**Subject:** Recommendations for Minimum Separation distances (MSD) for Tourtelot OE Removal Action, Former Benicia arsenal.

SUBJECT: Response to follow-up questions (transmitted via email on 18 October 2000) on the 29 September 2000 Memorandum for Record, Subject: Recommendations for Minimum Separation Distances (MSD) for Tourtelot OE Removal Action, Former Benicia Arsenal.

Response to Follow up Questions on the U.S. Army Corps of Engineers Recommended Minimum Separation Distance (MSD) for Ordnance and Explosives (OE) Removal Actions at the Tourtelot Site, Benicia, California.

### TOURTELOT CLEANUP PROJECT ORDNANCE AND EXPLOSIVES REMEDIATION MINIMUM SEPARATION DISTANCE

**FIGURE 1. Most Probable Munitions (MPM) and Minimum Separation Distance (MSD) for Tourtelot Property, Sectors 3A and 3B.**

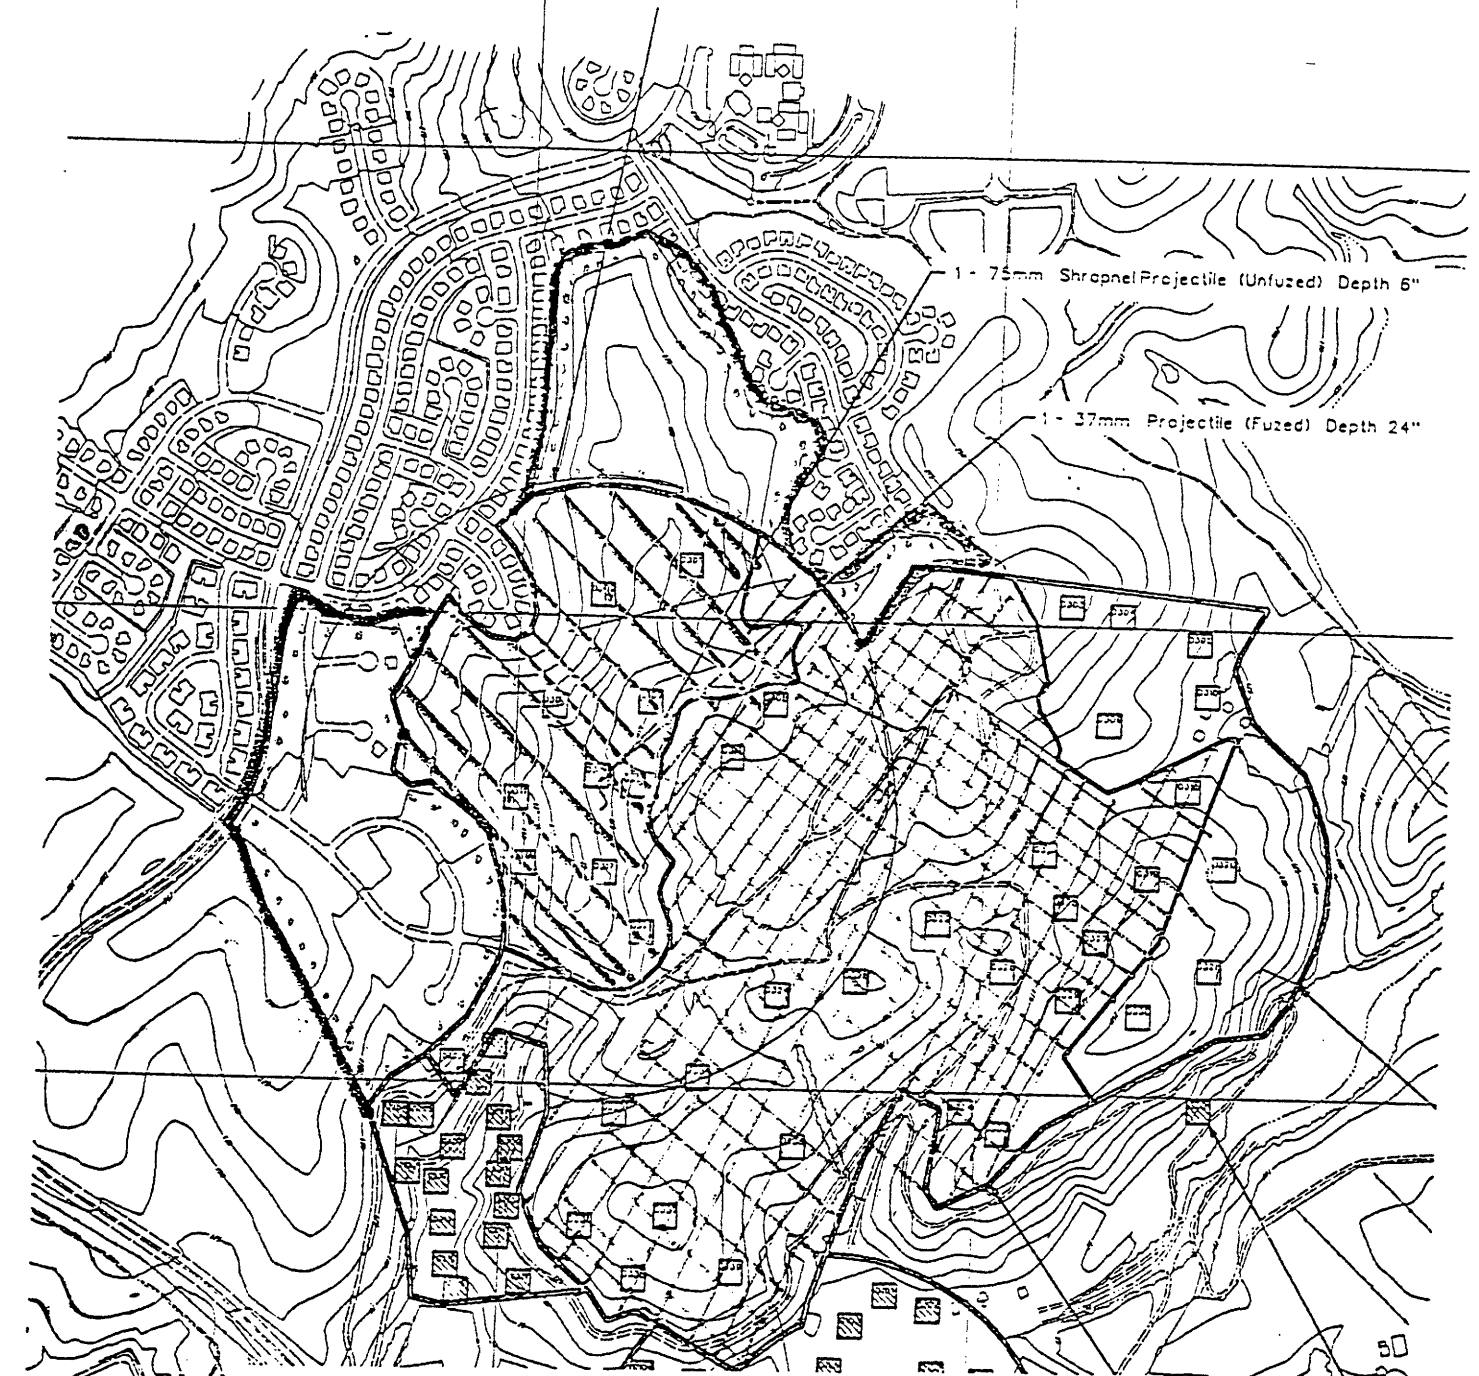
1. The map contained in the Memorandum for Record is unclear as to which MSD should be used in the areas where Sectors 3a and 3b overlap. Please clarify which MSD should be used in the overlap areas.

4. Please provide DTSC a copy of the color maps (including any necessary revisions as requested in 1, 2 and 3 above) identifying the MSD locations. It is difficult to understand the maps in black and white.

Based on the potential kick-out area and area 3a and 3b boundary lines, there appears to be an overlap of MSD areas around and overlooking Sector 2 and D-1. Should the MSD be revised to reflect the larger of the two MSD's in areas of overlap?

16. Page 3: Map; The MSD for the D-1 area, the western portion of the south valley and the northern portion of the South Valley is not clearly understood. Please provide the approved MSD that should be used in these and any other undefined areas on the Tourtelot site.

Response: To further clarify the MSDs, the single map contained in the 29 September 2000 MFR has been replaced with three separate color-coded maps (figure 1, 2, & 3). The maps reflect a MSD of 200 feet for Sector (3a) and Sector (3b). The original MSD Memorandum For Record (MFR) of 29 September 2000 has been revised by adding the three figures (see attachment (e)).

Response: As previously discussed, to further clarify the MSDs, the single map contained in the 29 September 2000 MFR has been replaced with three separate color-coded maps (figure 1, 2, & 3). The maps reflect a MSD of 200 feet for both Sectors so there is no larger MSD. The original MSD Memorandum For Record (MFR) of 29 September 2000 has been revised by adding the three figures (see attachment (a)).
